THE HILLS SHIRE COUNCIL

Rouse Hill Hospital

Lots 311 and 312 DP 1274392, Lot 229 DP 1249147, Lot 101 DP 1060353, Lot 2011 DP 1131519, Commercial Road, Rouse Hill

The proposal has been reviewed and the following comments are provided for your consideration.

Figure 13: Daily parking accumulation profile for staff, patients and visitors

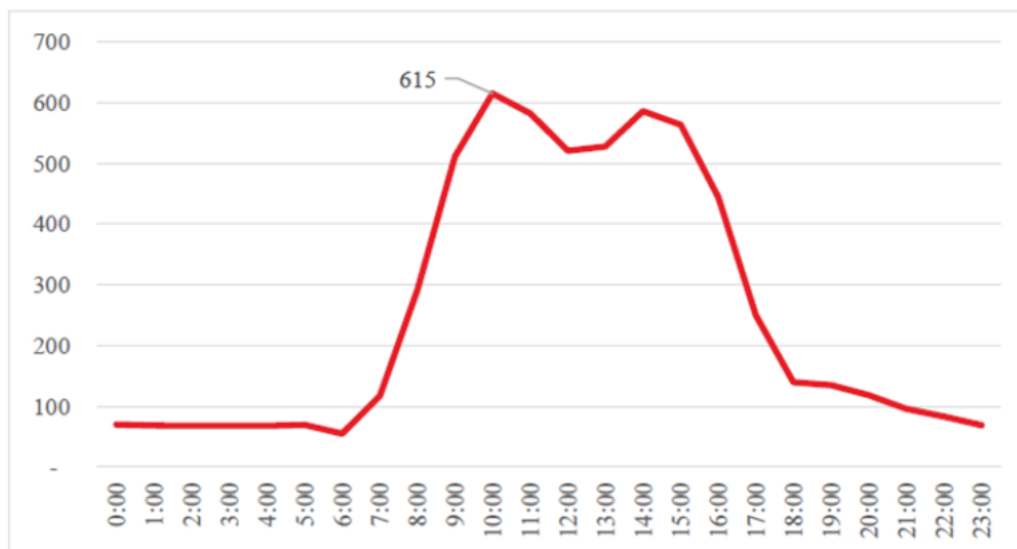
The peak parking demand is derived from the peak point of a graph in the study however there is no evidence showing how the demand and peak period axes were determined.

Figure 22: Daily departure/arrival profile for staff (note percentages are rounded)

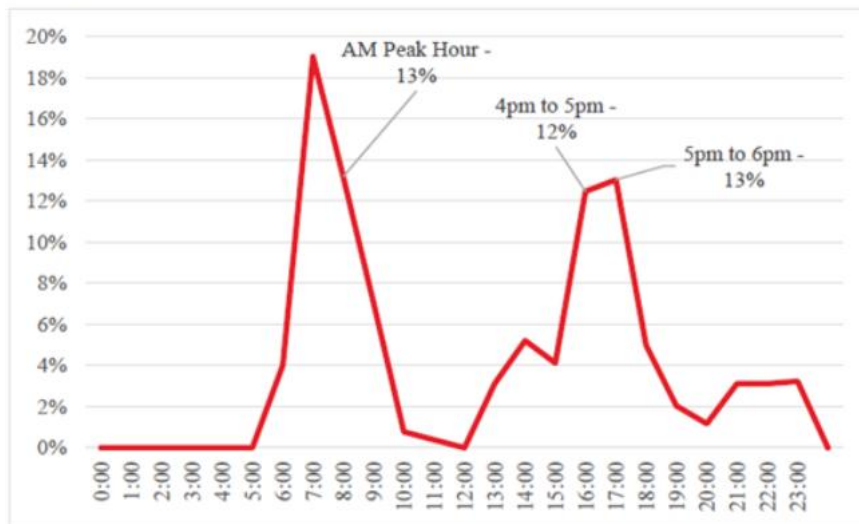
Similarly, the peak hour person and vehicle trips are also based on graphs produced by the applicant's traffic consultant with no supporting evidence.

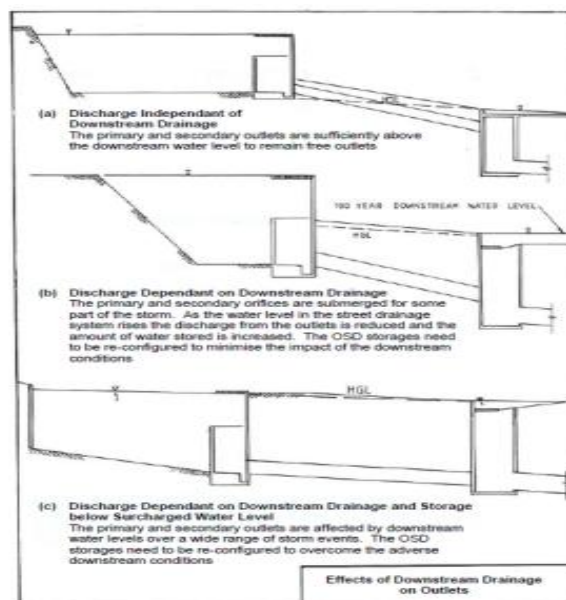
- Check whether the OSD is impacted by Drowned outlets. Refer to Figure 6.3 of the On-site Stormwater Detention R3, of the Handbook Upper Parramatta River Catchment Trust, and the snapshots below:

Options "B and C" will not be supported, therefore, ensure the depth of the OSD is reduced and Options "B and C" are avoided
